**Marion County
Board of County Commissioners**

**PLANNING & ZONING SECTION
STAFF REPORT**

P&ZC Date: 10/28/2024	BCC Date: 11/19/2024 REQUEST CONTINUANCE TO DATE CERTAIN 12/17/2024.
Case Number	241107ZP
CDP-AR	31944
Type of Case	Rezoning from General Agriculture (A-1), Community Business (B-2), and Rural Activity Center (RAC) to Planned Unit Development (PUD)
Owner	Castro Plaza, LLC. and Austin International Realty, LLC.
Applicant/Agent(s)	G. Matthew Brockway of Icard Merrill
Street Address / Site Location	6998 N. US Hwy 27, Ocala, FL, 34482
Parcel Number	13676-001-00, 13675-000-00
Property Size	±43.62 acres
Future Land Use	Commercial (COM)
Zoning Classification	General Agriculture (A-1), Community Business (B-2), Rural Activity Center (RAC)
Overlay Zone/Scenic Area	Urban Growth Boundary (UGB), Secondary Springs Protection Overlay Zone (SSPOZ)
Staff Recommendation	APPROVAL WITH CONDITIONS
P&ZC Recommendation	APPROVAL WITH CONDITIONS
Project Planner	Kathleen Brugnoli, Planner
Historic/Related Case(s)	860733Z – A-1 to B-2 – Approved; 120501Z – A-1 to Rural Activity Center (RAC) – Approved; 220905SU – Special use permit for overflow grass parking – Approved;

Figure 6
Martingale Site Plan

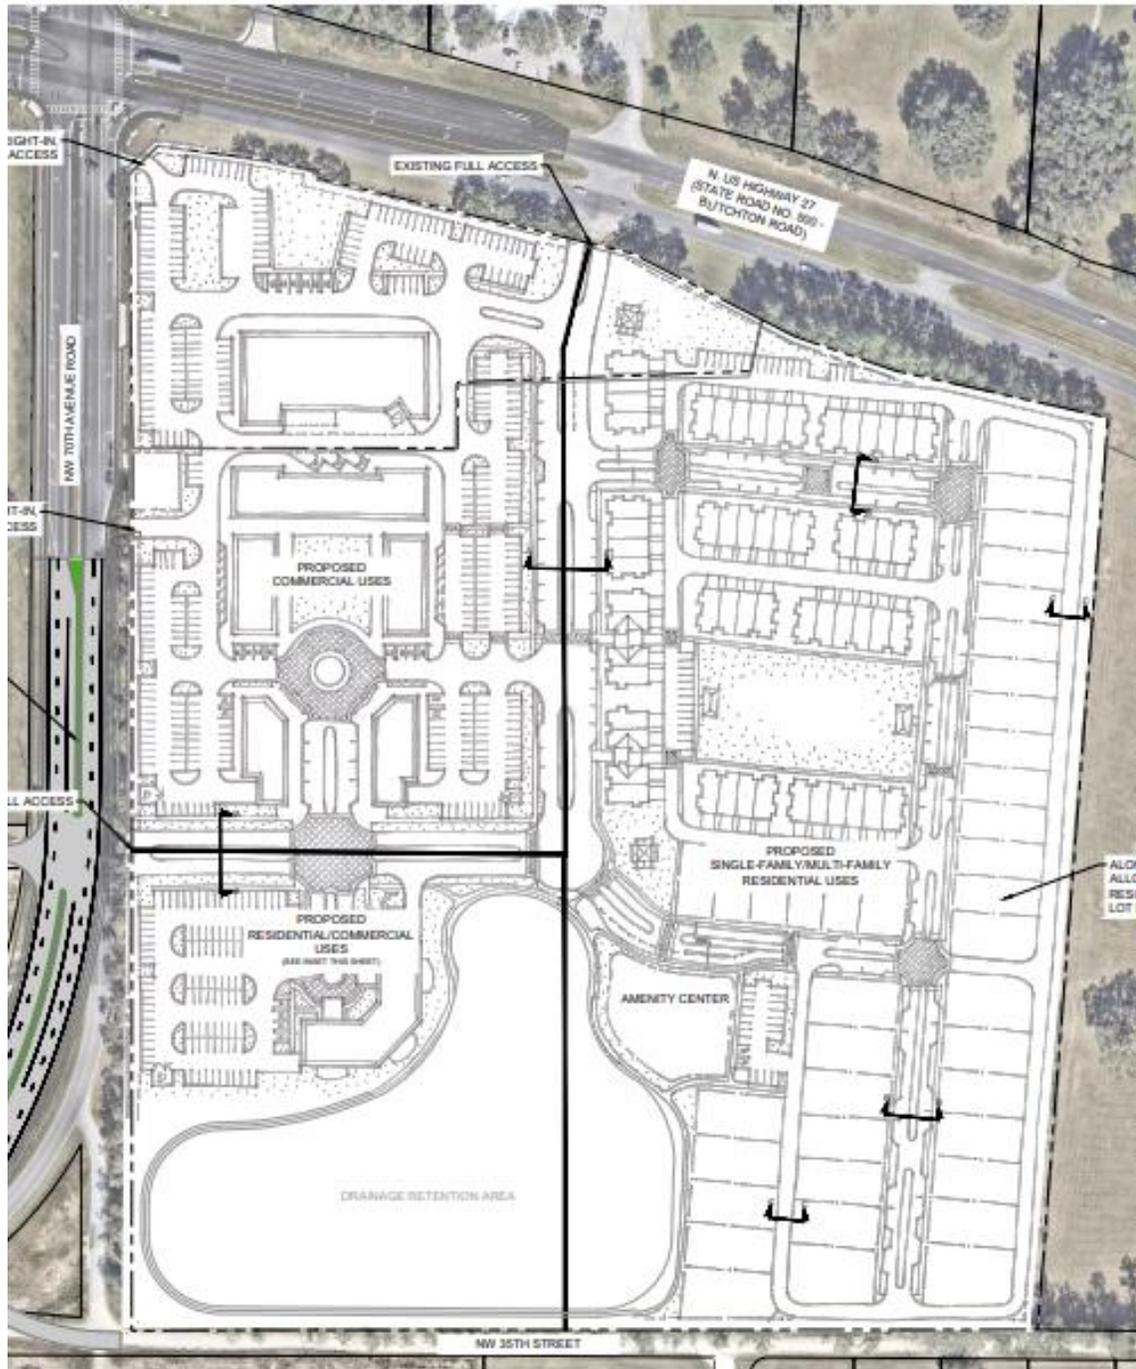
Maximum building height for Commercial areas is limited to 45' while the Residential component proposes a maximum building height of 35' for townhomes and 30' for single-family detached homes. Based on the height limitations and the conceptual plan providing all lots contiguous to the neighboring property to the east, which is a single-family property, staff finds the setbacks and buffers proposed appropriate for the Planned Unit Development plan.

Table 2 below summarizes the PUD's proposed and *staff's recommended setbacks for the PUD*:

TABLE 2. SETBACKS (IN FEET)			
Direction	Adjoining Use	Proposed	Recommended
North	ROW	40'	40'
South	ROW	30'	30'
East	Agriculture	30'	40'
West	ROW	40'	30'

Table 3 summarizes the PUD's proposed, and staff's recommended, buffers for the PUD. Attachment A Page 70 includes buffer diagrams for each of the PUD's proposed buffering types. Also, note 4 included on the buffer plan states that the design for the PUD intends to allow development signage within perimeter landscape buffers provided they are integrated in to the buffer design in an aesthetically pleasing manner. Staff will include the as a condition to allow for signage within the buffers.
